KAMIRA AVENUE VILLAWOOD

COUNCIL RFI - URBAN DESIGN REPORT

NOVEMBER 2022

ABOVE GROUND PARKING FACADE SECTION

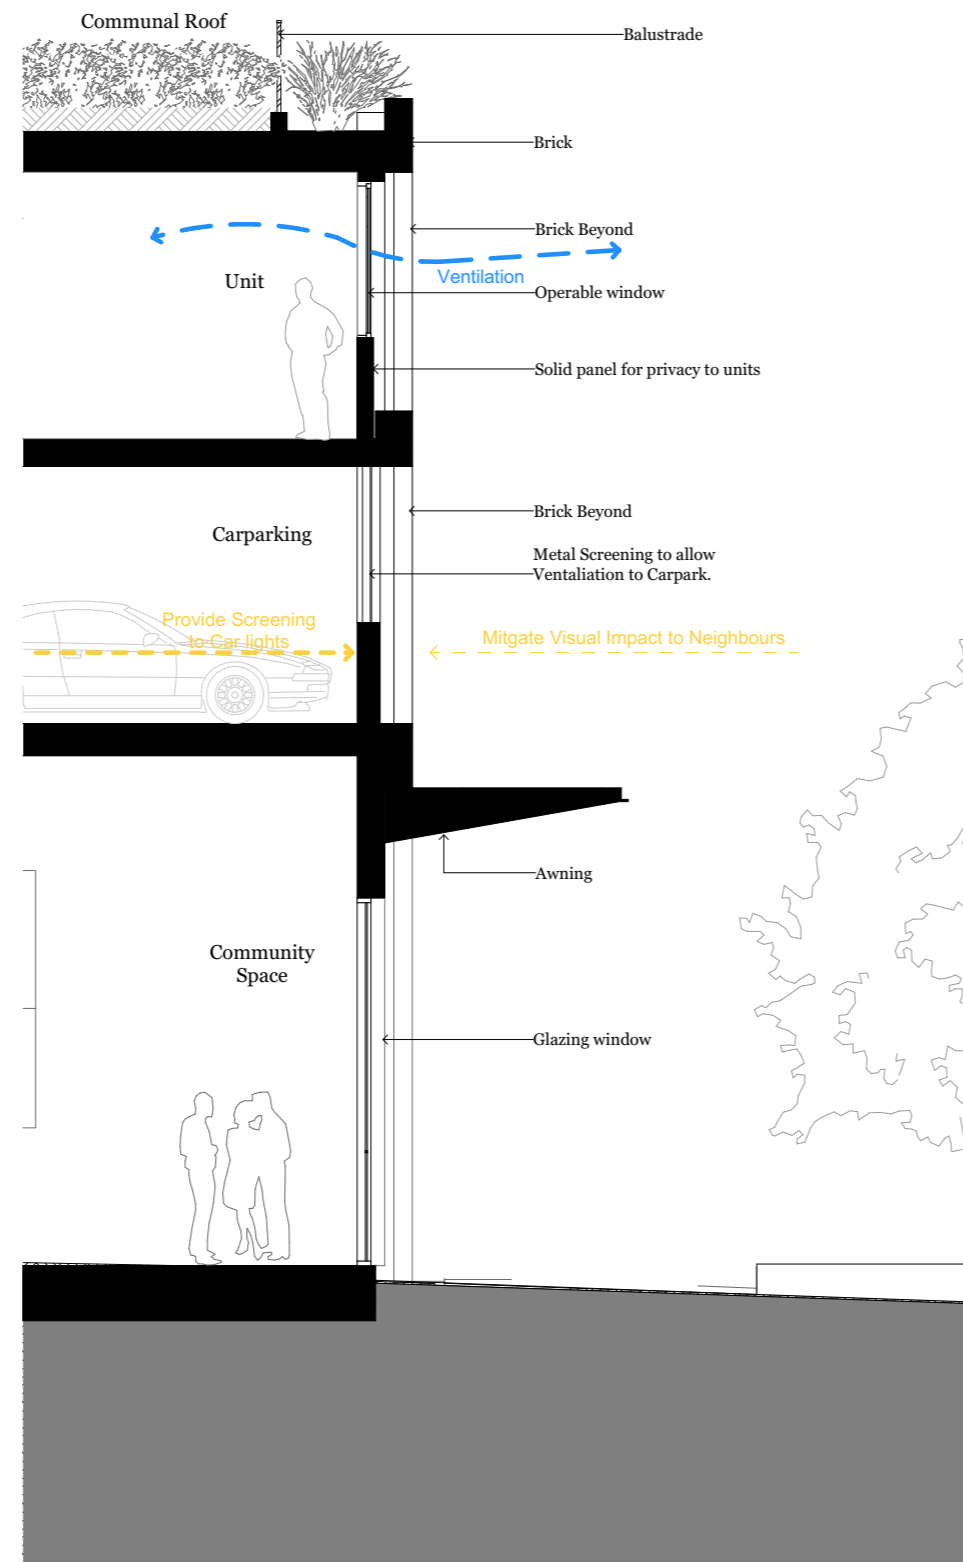
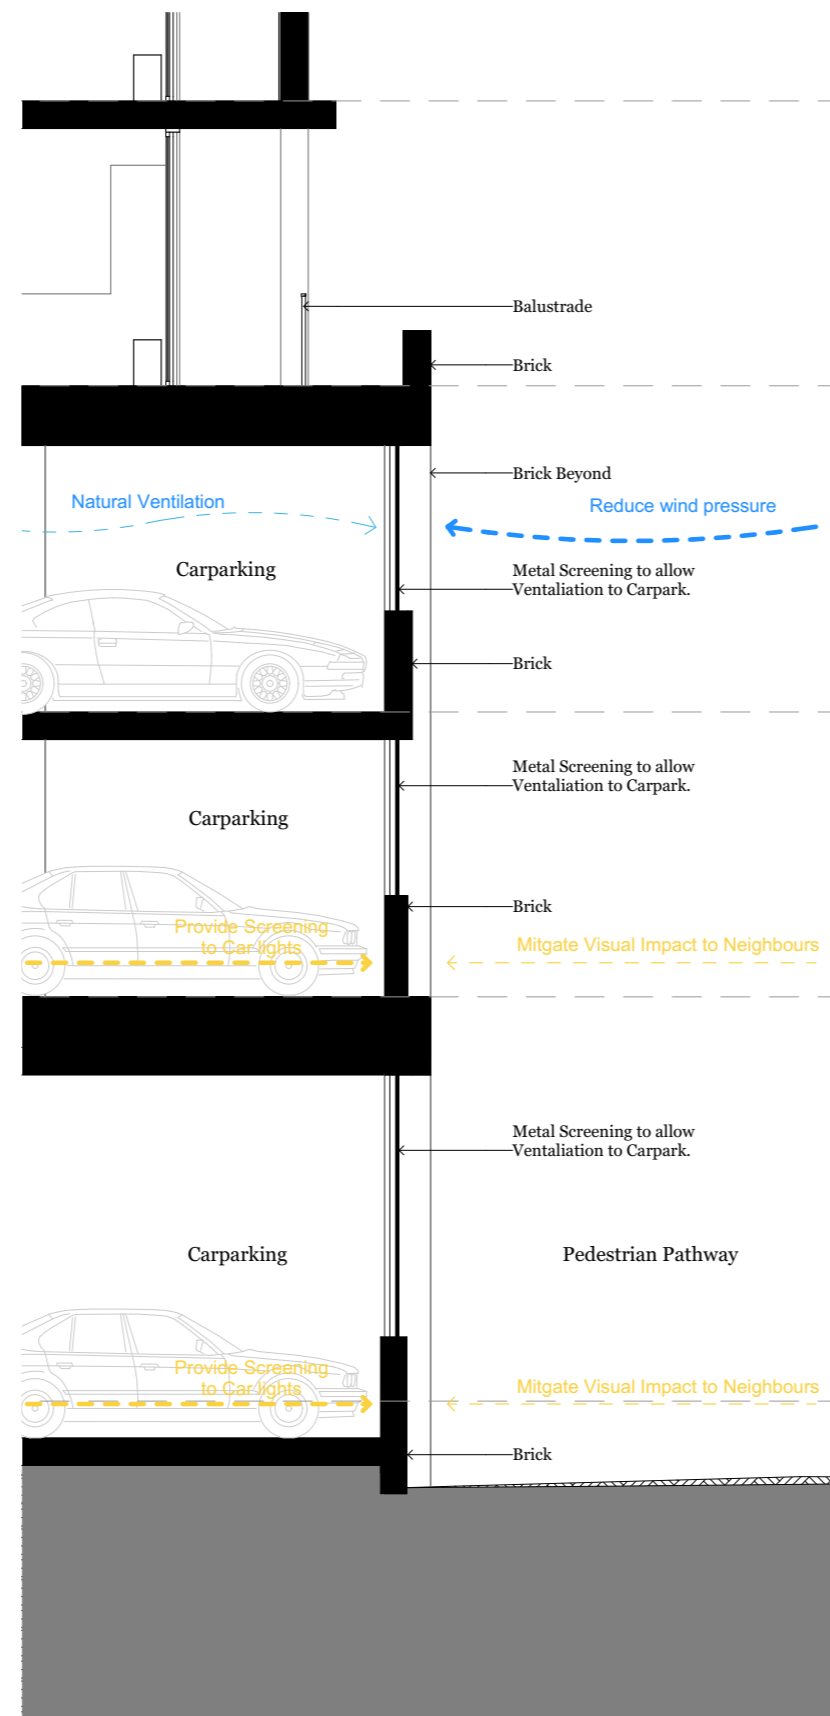
The proposal still involves the provision of car parking in a podium arrangement. Whilst it is acknowledged that architectural elements including screening structures are proposed to mitigate the visual impact of the spaces, it is considered that the positioning of car parking spaces on and above ground level is an inappropriate arrangement. This arrangement results in design issues such as elongated corridors, extensive distances to lifts and lost opportunities to provide high quality ground floor apartments and position back house areas in inconspicuous areas. Furthermore, Clause 4.8 of the Villawood Town Centre Development Control Plan 2020 states that car parking is to be provided in an underground basement. Accordingly, parking spaces must be provided in a basement level to conceal the spaces, improve the ground floor layout and provide a high quality and contemporary development.

Above Ground Parking is an appropriate response to the improved urban design approach to the site, that intentionally contributes to the place making of Villawood. Above ground parking also has immediate long term ESD benefits and future use opportunities.

Clause 4.8 of the Villawood Town Centre Development Control Plan 2020 states that car parking is to be provided in an underground basement.”, Clause 4.8 states “Car parking is to be provided in an underground basement, or where appropriate, sleeved with active uses to main street frontages”

Further, the southern frontage is not identified as an Active Street Frontage, unlike Kamira Court - whereby significant activation on the ground floor is provided through residential apartment and residential lobbies activating the ground floor below sleeved car parking.

BUILDING HEIGHT 3D PERSEPECTIVE

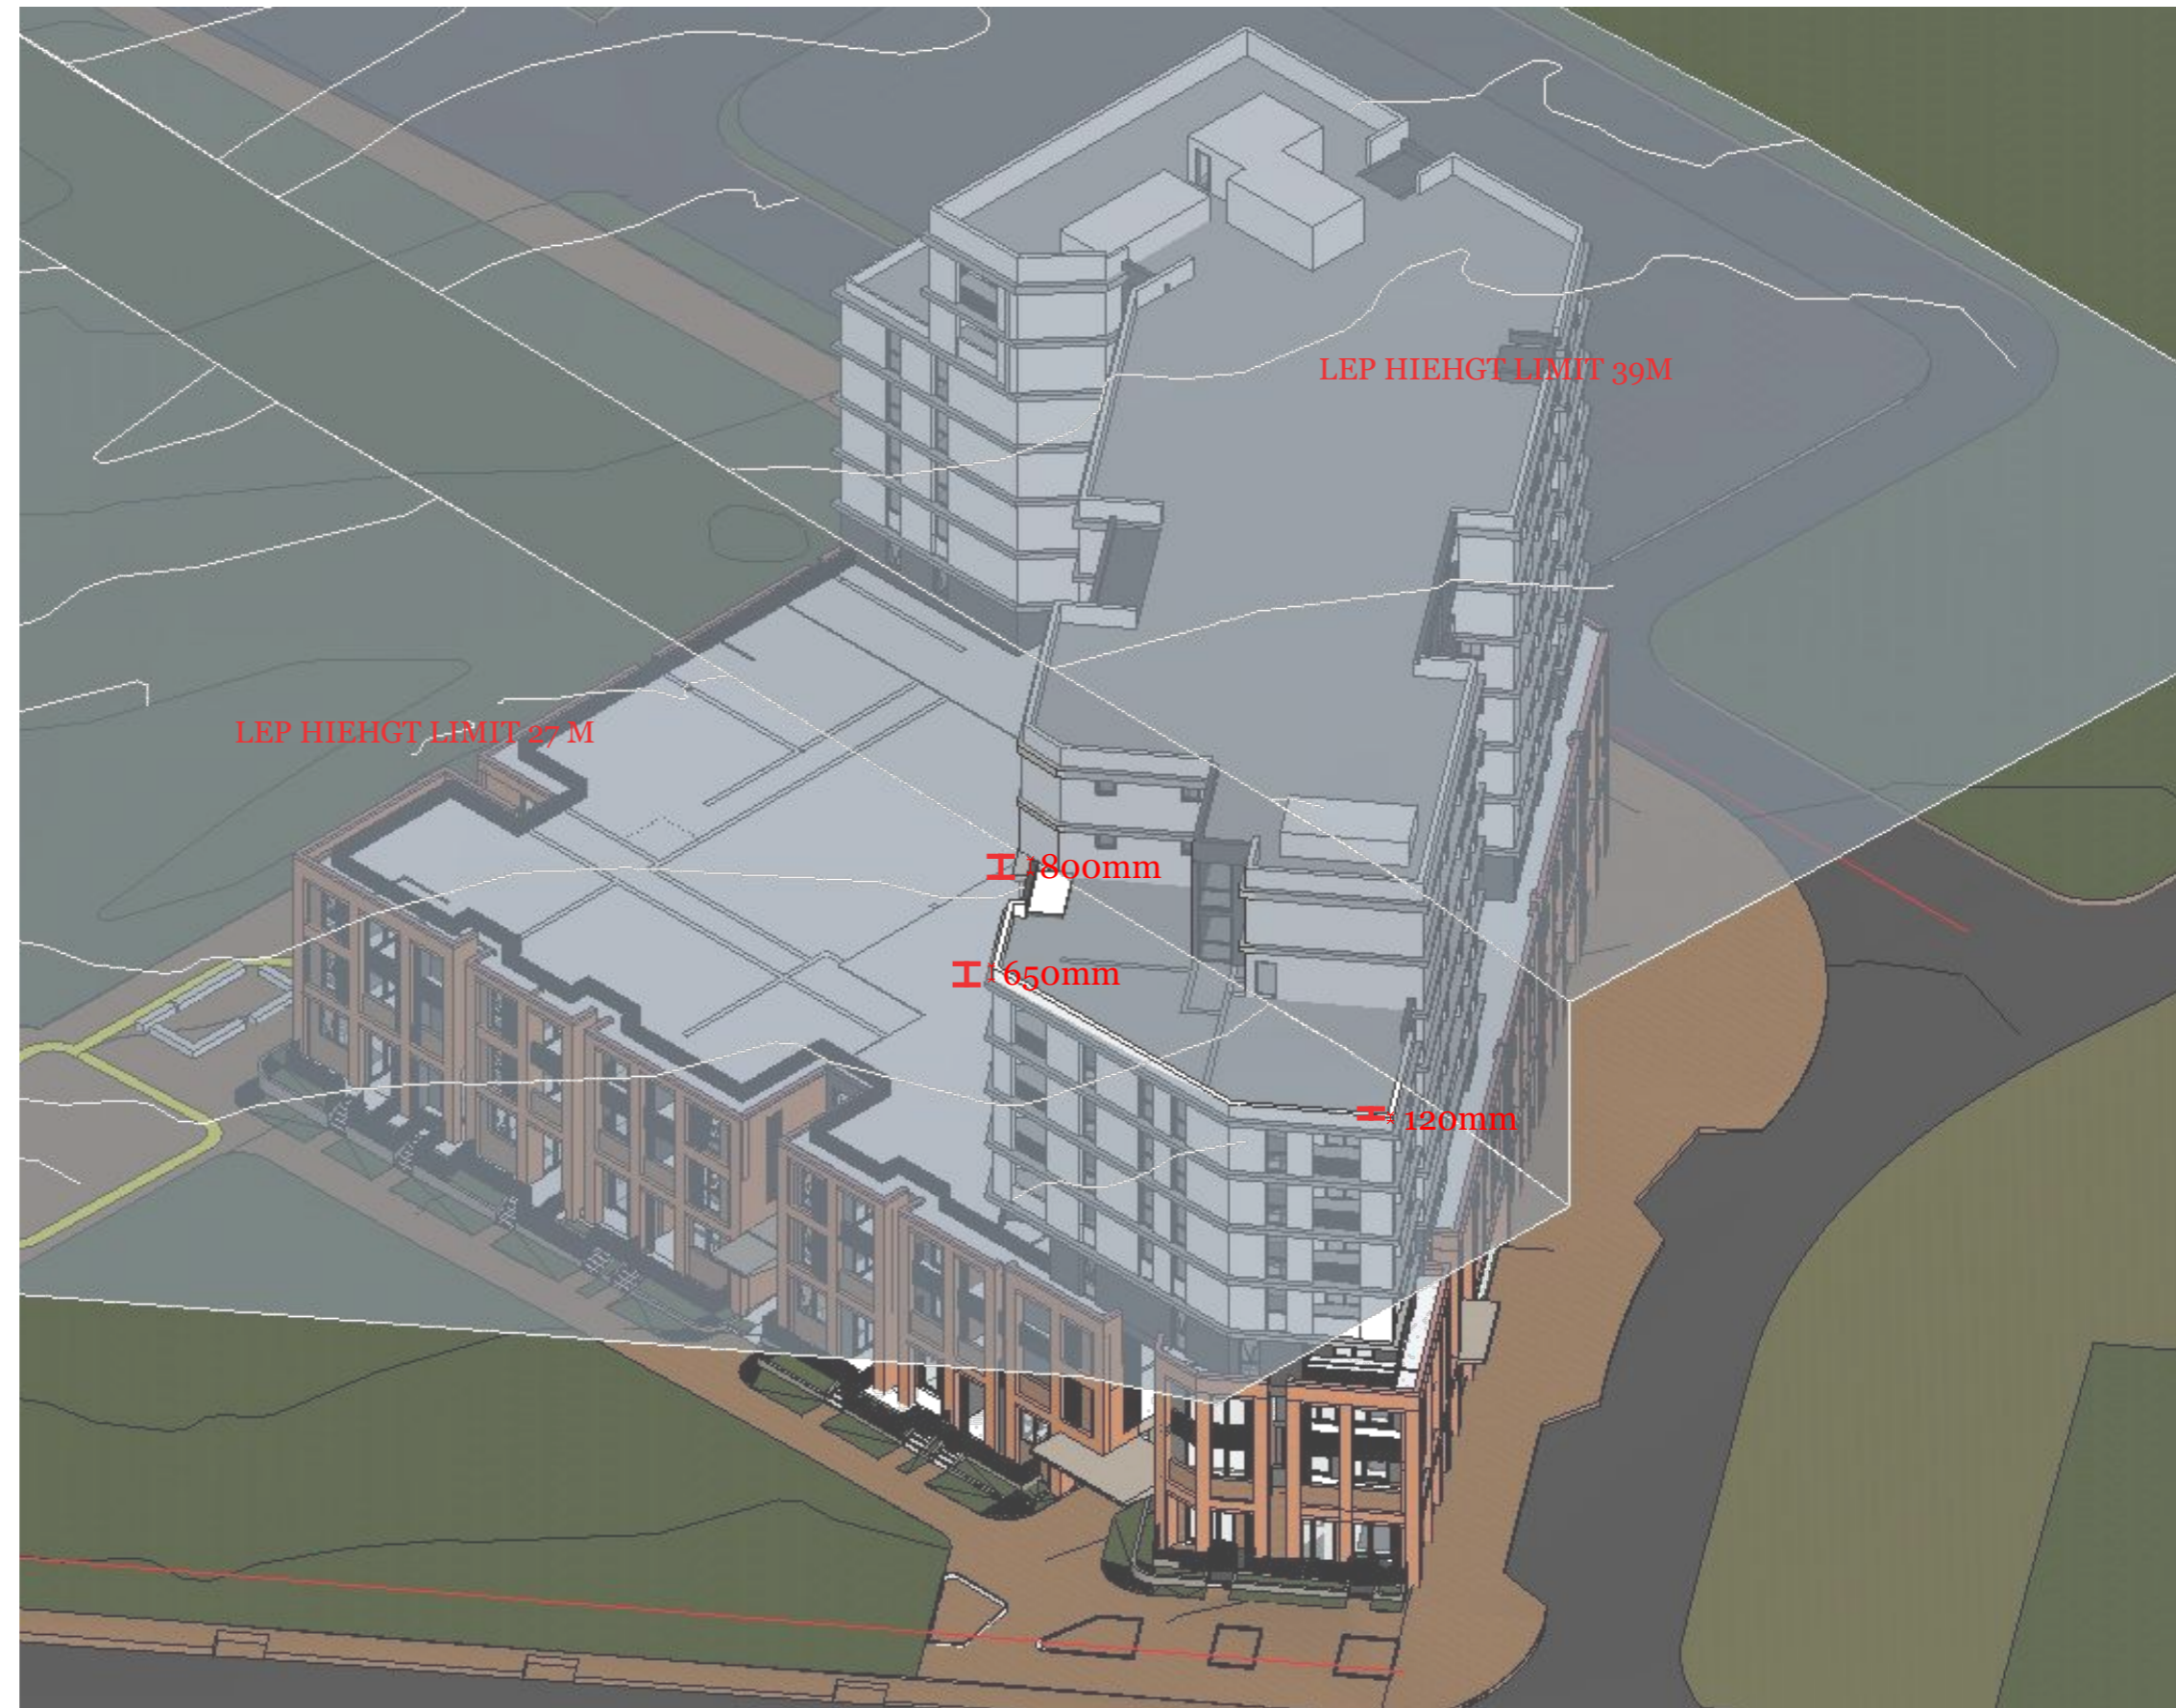
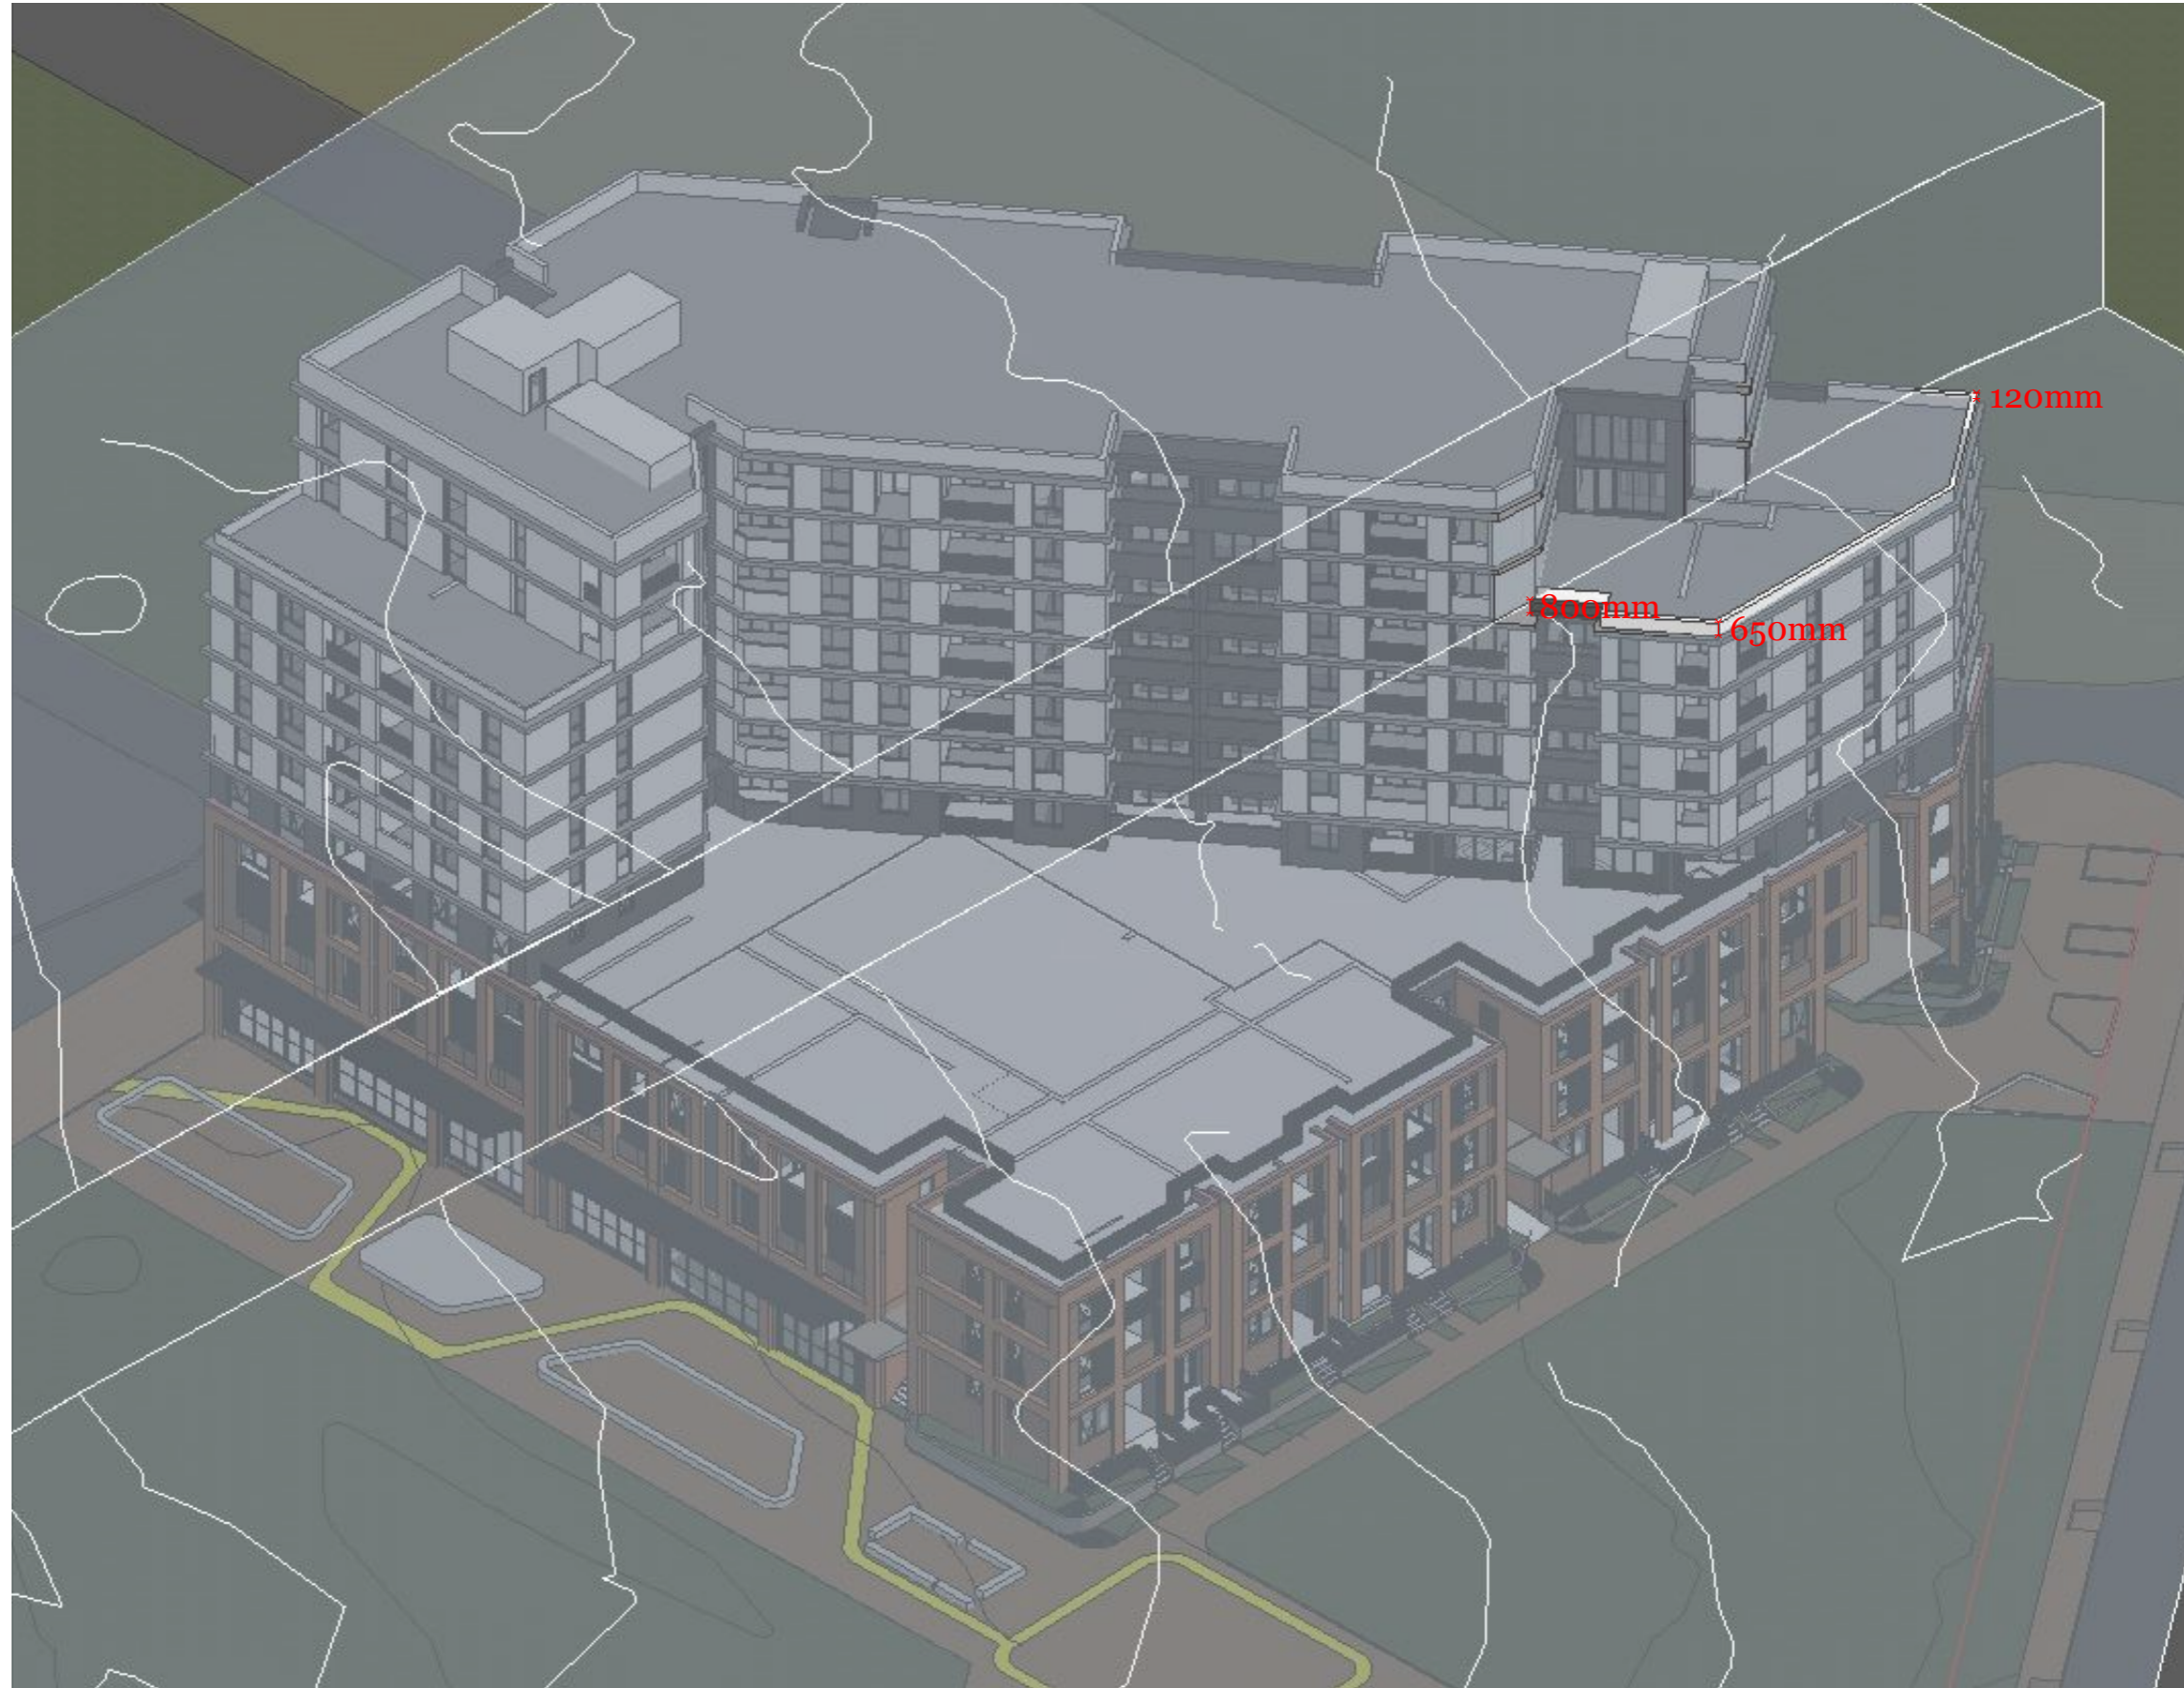
The application still proposes a non-compliance with the LEP 2013 building height due to the over-run of the parapet to Level 8 of the apartment building. Furthermore, the proposal involves an additional 2 storeys above what the Villawood DCP allows on the southern portion of the site

The majority of the proposed 10 storey building complies with the prescribed height control; however, the proposal does incorporate a minor variation to the building height control. The minor non-compliance is limited to the parapet to Level 8 to the 27m height provision, a maximum encroachment of 1800mm or 28.8m.

It is noted that the majority of the building form including all habitable areas are contained below the maximum permitted height control.

The additional two storeys mentioned are still within the LEP 2013 height plane and are therefore not an LEP consideration. This adjustment of GFA was a resultant of shifting the 6-storey separate building from the south-west corner of the site (as originally proposed in the DCP) and including this area within the proposed building. It is noted that no additional GFA is sought from this adjustment to building form and the shadow impacts and solar opportunities have been addressed in earlier sections.
